PLANNING BOARD WORKING MEETING

a. Project: Site Plan, Village Solar Phase VII

VILLAGE CIRCLE-VILLAGE SOLARS PDA - PHASE VII 1067 WARREN ROAD LANSING (T), NEW YORK

Village Solars Phase 7 – Response to August 18, 2022 TG Miller Comments

DATE: Sept 6, 2022
SCALE: 1"=50'
DRAWN: SDG
JOB:
SHEET: **ST-5**

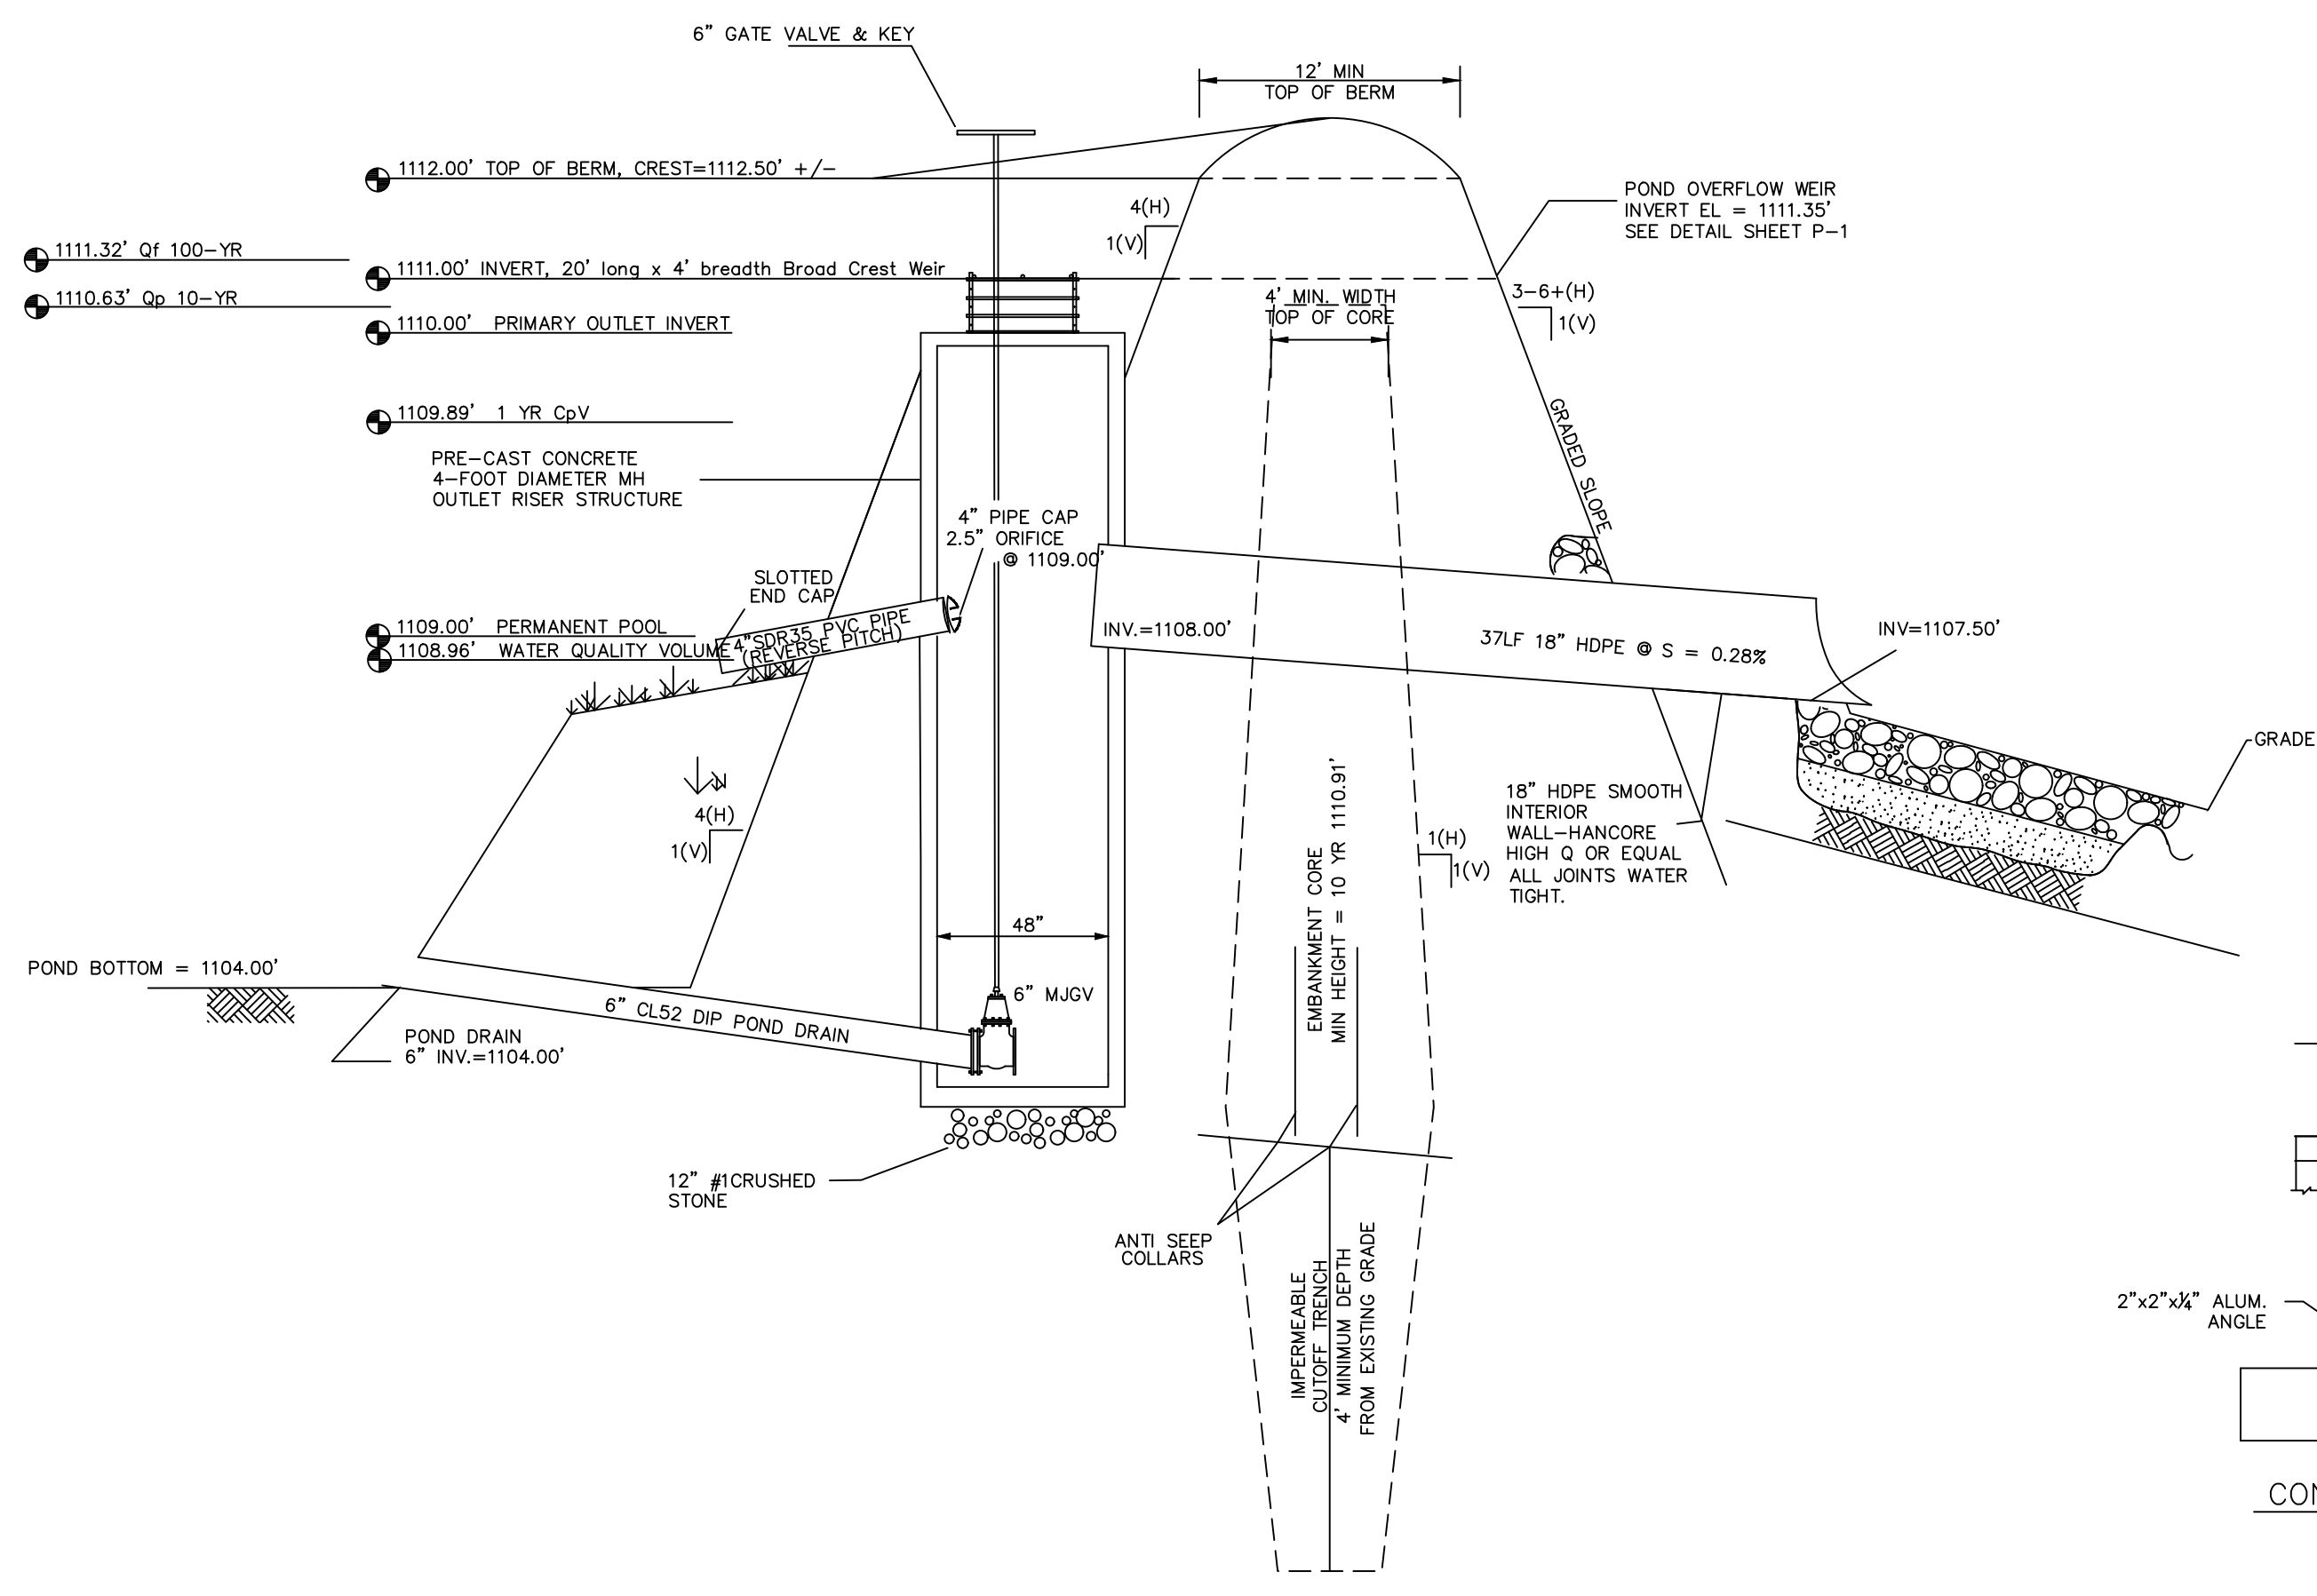
13. Comment: Check the sizes and elevations of the bioretention areas on Sheet ST-5 with that of the SWPP.

15. Comment: There is a discrepancy between the site plan and model for the size of the bioretention area underdrains

16. Comment: Issues with the porosity of the filter media by surface area reduction. Revise so that they correspond to cross section.

Response: *Corrections have been made to the table.*

Response: *The bioretention area details have been adjusted to 4" to match model.*

Response: *This iteration of the model used a previous version from several years ago as a template. All bioretention area layers have now been updated to match the filtration detail as well as to address the void areas of the stratum.*

DATE: Sept 6, 2022
SCALE: N.T.S.
DRAWN: SDG
JOB:
SHEET: ST-6a

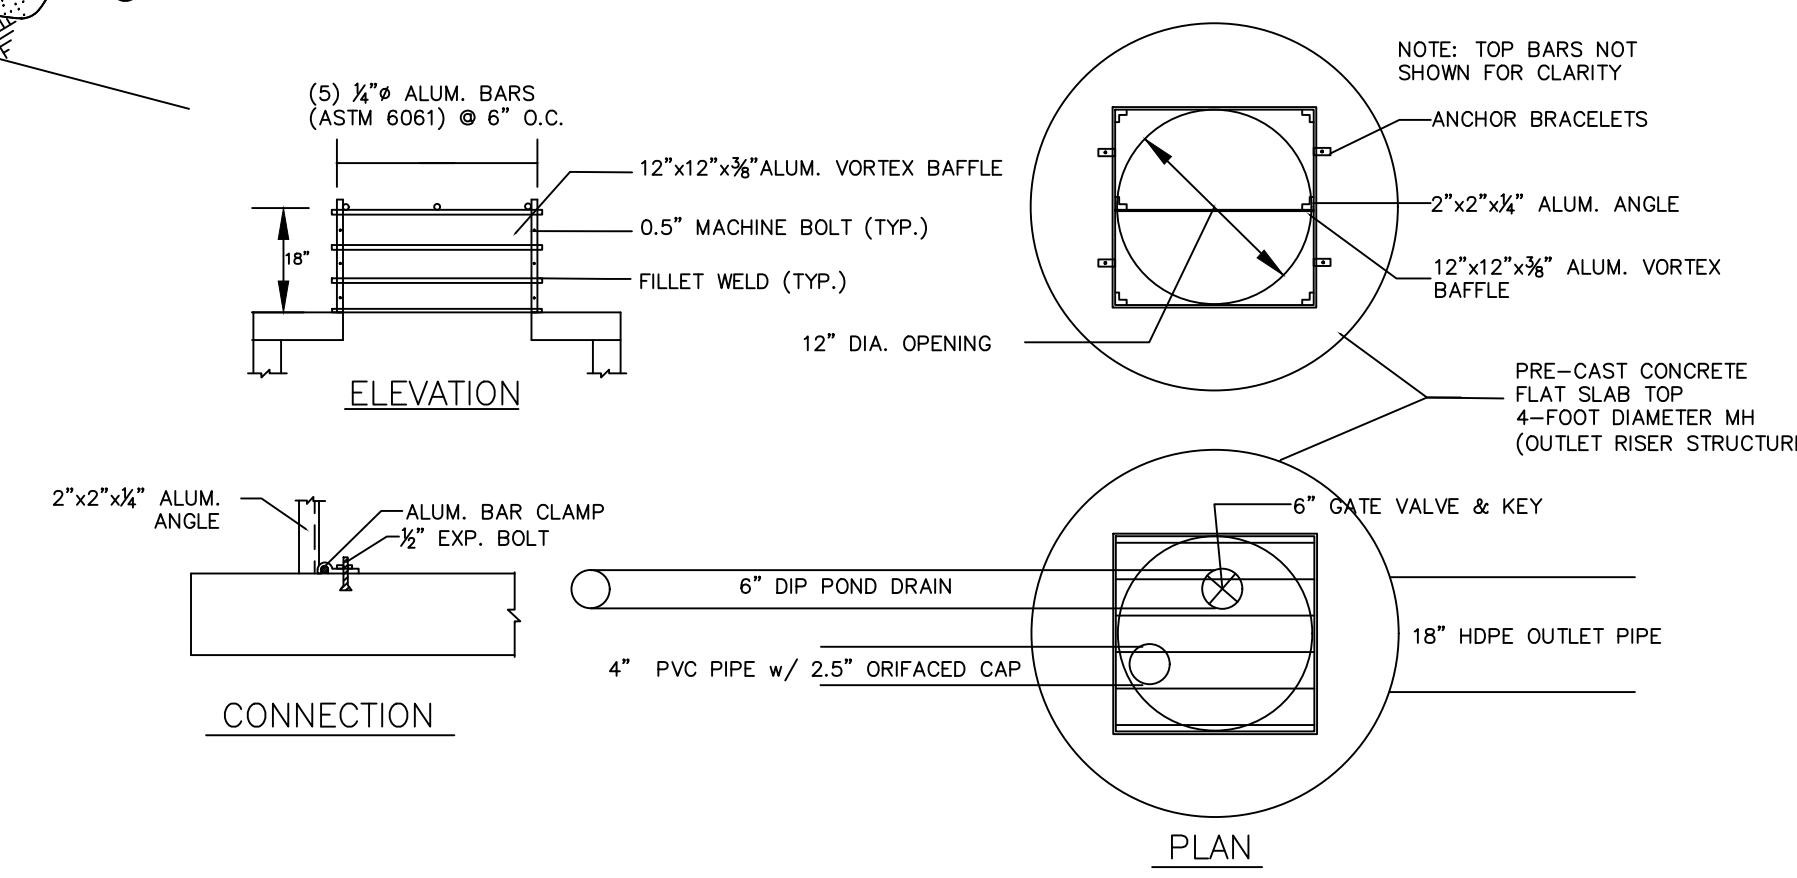
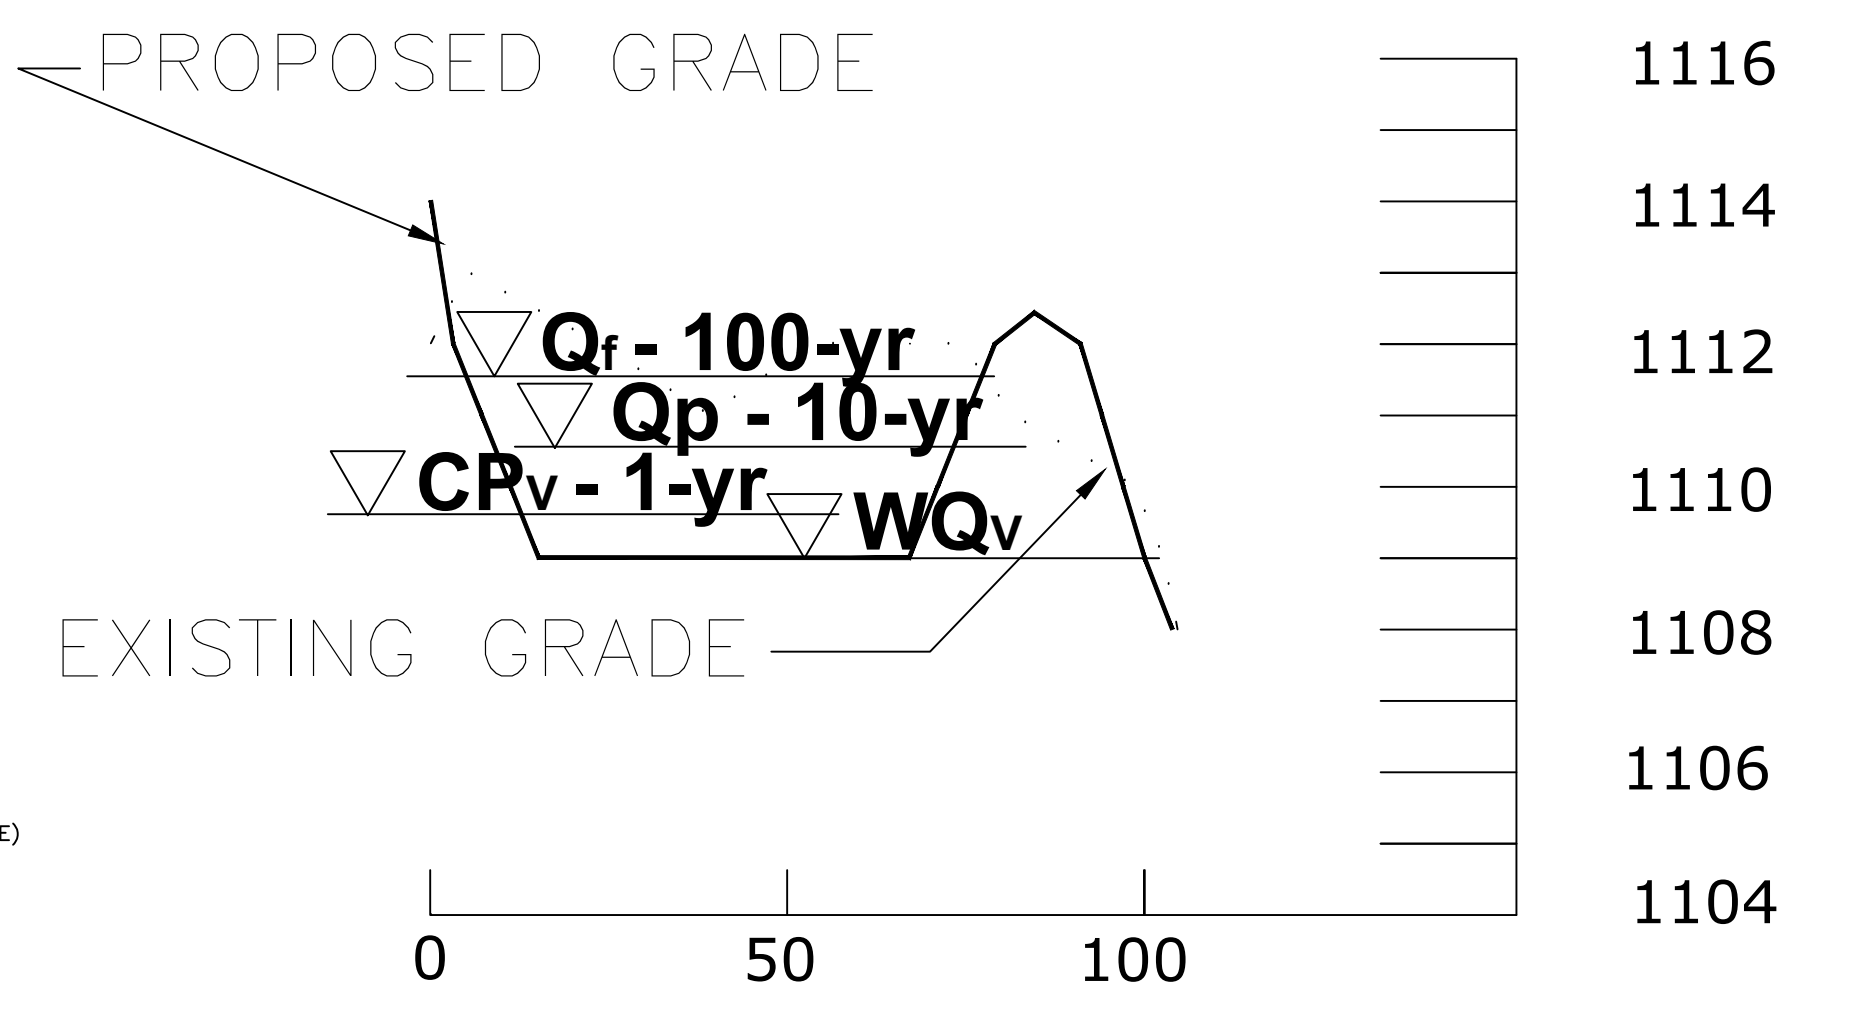
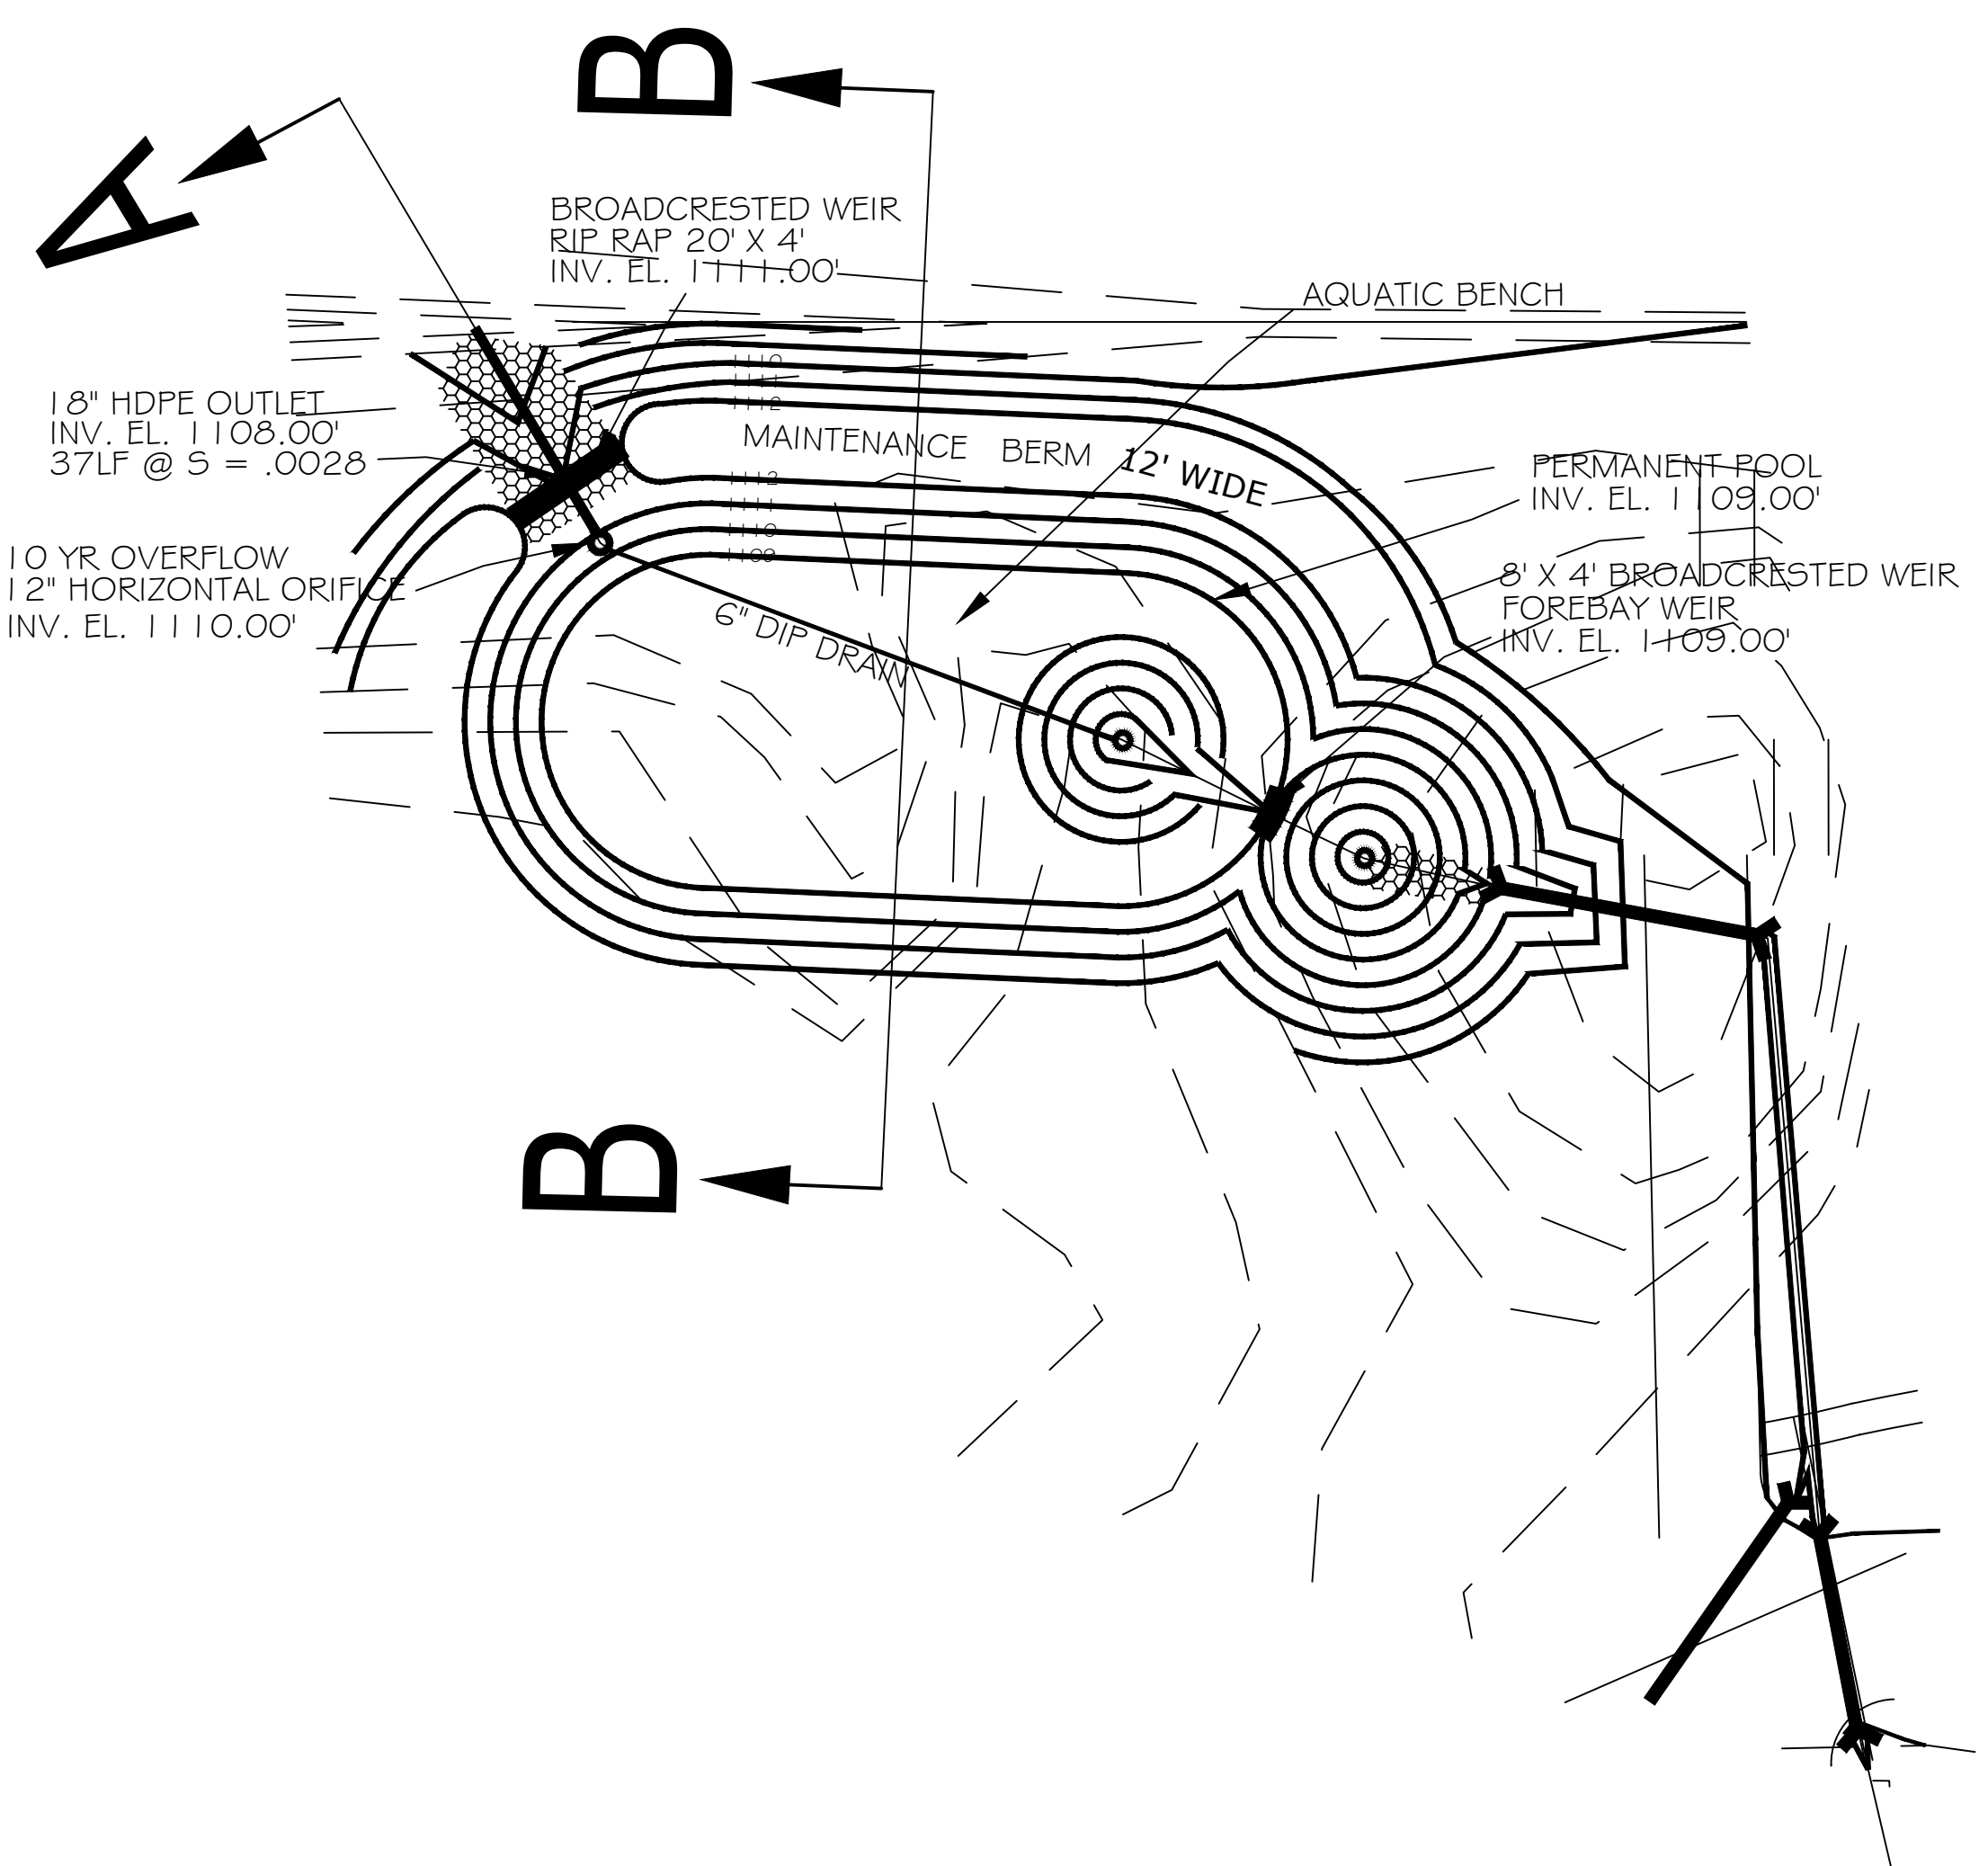
12. Comment: There is a pond shown on the subcatchment map but there is no further information on this structure.

Response: *The missing pond design sheet has now been included to the plan set, and the site plan has been updated to show Pond 1, which is required for the attenuation of OSC-3.*
